**CITY OF WEST DES MOINES
STAFF REPORT COMMUNICATION**

ITEM: Oaks on Grand Phase 2, 5725 Raccoon River Drive – Approve Major Modification to Site Plan to allow construction of an approximately 10,000 square foot office building – JCG Equity, L.L.C. – MaM-006505-2024

Resolution: Approval of Major Modification to Site Plan

COLOR EXTERIOR
ELEVATIONS

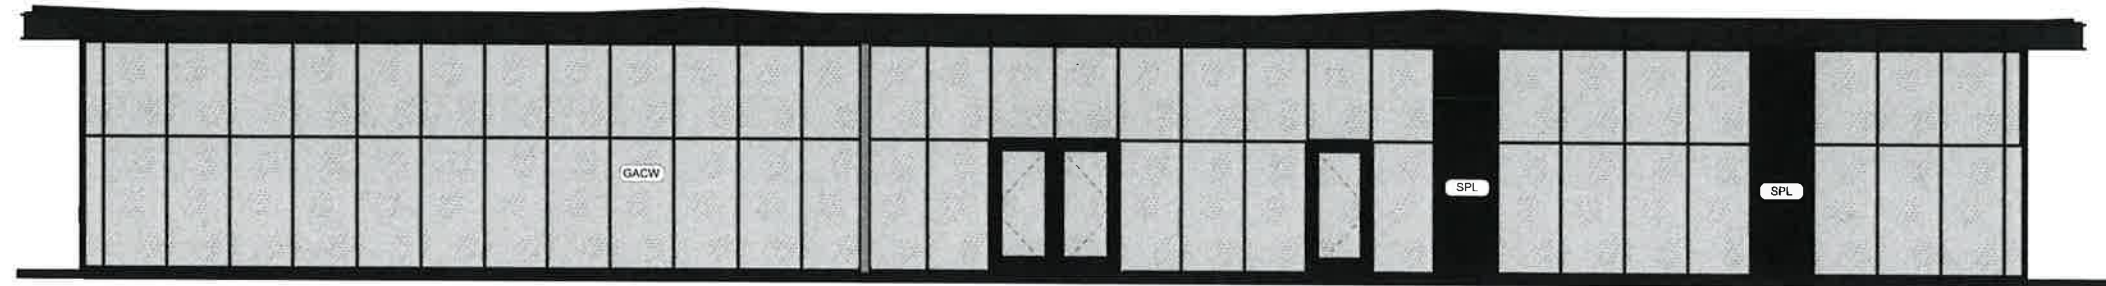
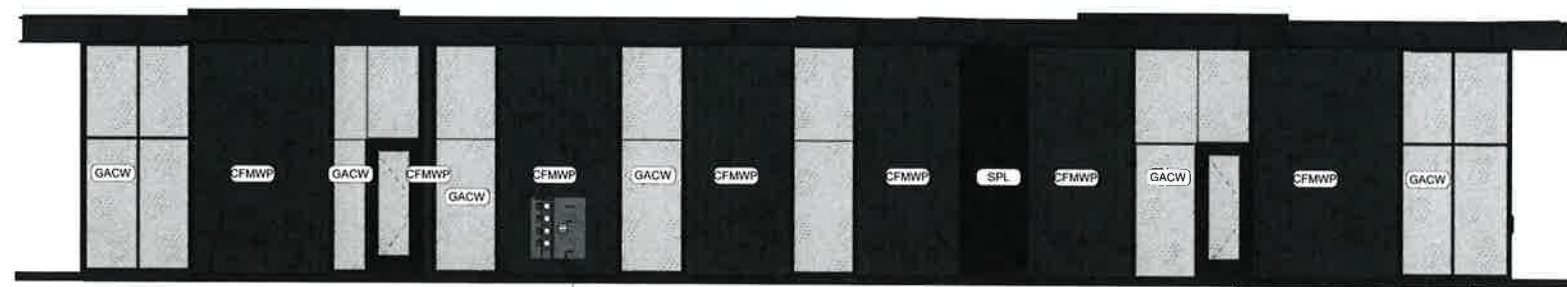
1. Does the proposed MAC Metal panel have an applied wood image or is the product textured with a wood like grain finish? The city has not typically permitted materials with an applied image finish. If possible, can a product sample be provided for staff review?

Staff Comment: As provided in an email from staff on July 16th, staff is not opposed to a metal material for the project, however, there is concern and past history regarding the use of a photo like applied finish metal products. The city has not allowed the use of metal products that have a photo like applied finish to mimic wood or other like products. The city has always looked for a wood simulated product to provide a textured finish to resemble the real feel/texture of real wood grain. Are there other options that would still provide the metal option for the project but that have a more realistic wood texture to provide the wood grain effect for the building?

Staff Comment: As noted in the email from staff on July 31st, if the applicant wishes to proceed forward with the materials as proposed, against staff recommendation, there will be an opportunity to present to the Commission. Prior to the Commission/Council meetings, provide in writing a brief description and reason on how you feel the proposed building design and material choices comply with the district, the surrounding character of the area and how the materials provide an accurate representation of the intended appearance of wood cladding.

NEED PRODUCT INFO

Applicant Response: THE PROPOSED MAC METAL PANEL HAS AN APPLIED WOOD IMAGE AND VARYING SHEEN TO REPLICATE STAINED/SEALED

WOOD (SEE EXAMPLE IMAGE BELOW FROM MAC METALS WEBSITE SHOWING THIS SPECIFIC PRODUCT). PHYSICAL SAMPLES SHOWING THE COLOR AND TEXTURE HAVE BEEN SUBMITTED FOR REVIEW.

Applicant Response: EXTERIOR METAL PANEL STYLE/FINISH IS BEING REVIEWED DIRECTLY WITH WDM PLANNING STAFF. DOWNING STUDIO WILL PROVIDE UPDATES TO ORCA AS THIS IS RESOLVED.
